1964 Corvette: Service Bulletin: Neutral Safety Switch Malfunction

Model and Year: 1964 Corvettes with Powerglide Transmissions

Bulletin No: DR #658

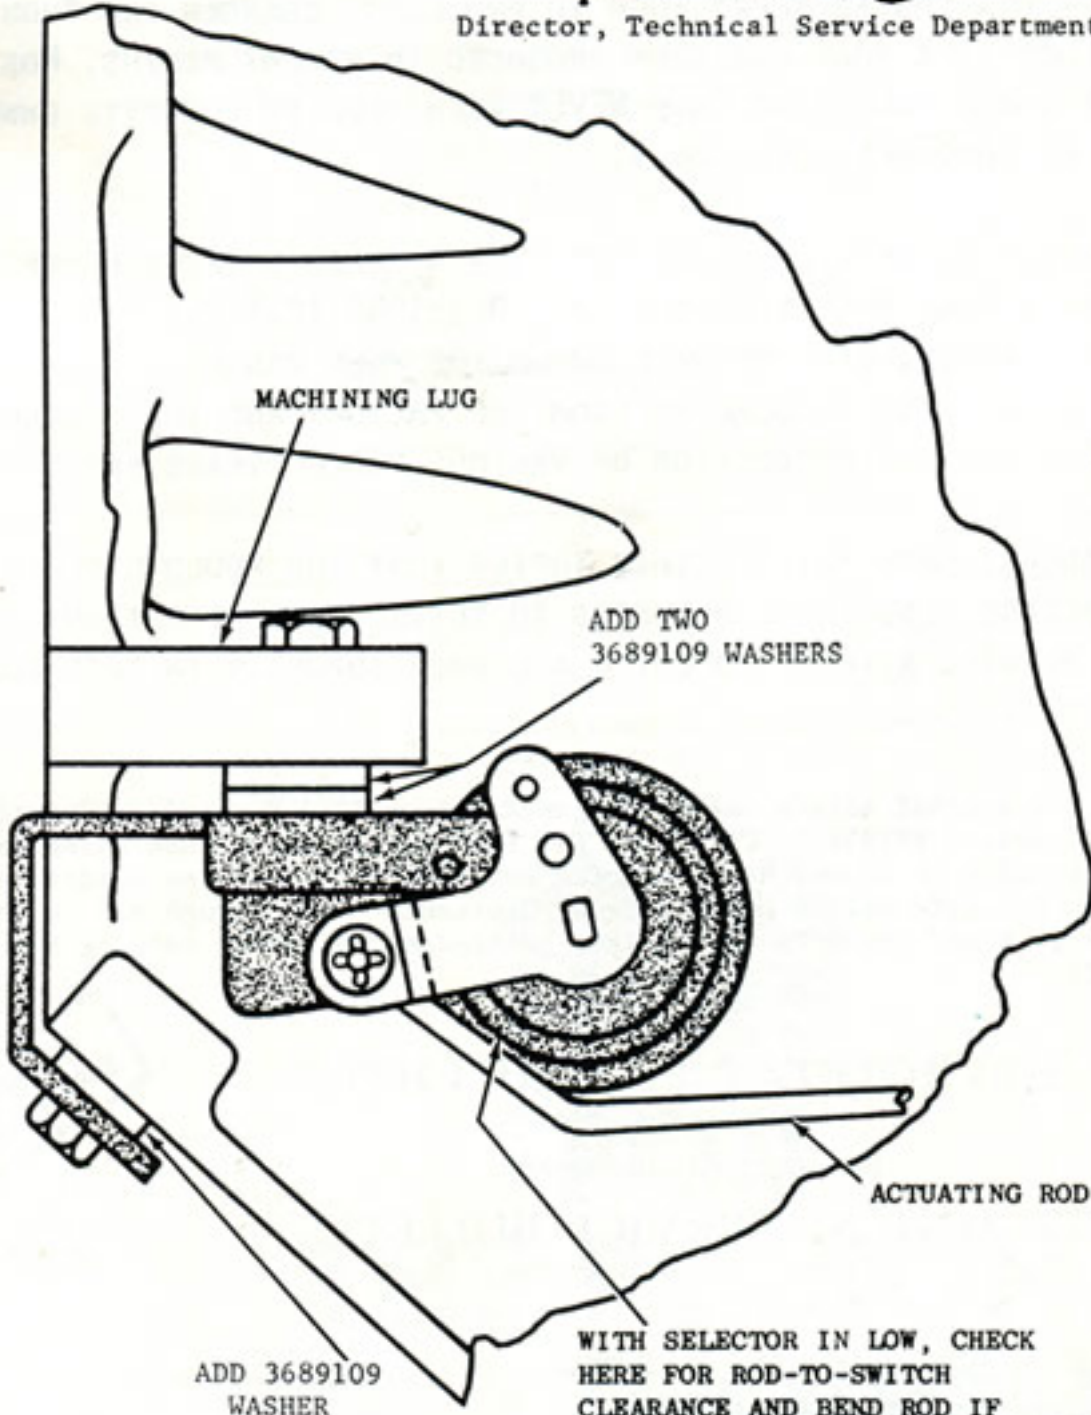
Interference between the neutral safety switch and the underbody may exist on some early production Corvette Models with Powerglide transmissions.

This could result in the engine being started while the transmission selector is in a drive position. In addition, the added load imposed on the shift linkage by the misalignment causes a reduction or loss of detent feel when the transmission is shifted manually. The transmission might then be accidentally operated between ranges and internal damage could result.

Correction of switch malfunction may be made by shimming the switch assembly downward as shown in the attached sketch. Note that operating clearance must exist between the switch body and the switch actuating rod after the shimming operation is completed.

WITH SELECTOR IN LOW, CHECK HERE FOR ROD-TO-SWITCH CLEARANCE AND BEND ROD IF NECESSARY. TEST ACTION OF SWITCH AFTER BENDING ROD & ADJUST LENGTH OF ROD AS REQUIRED BY TURNING THREADED PIVOT.
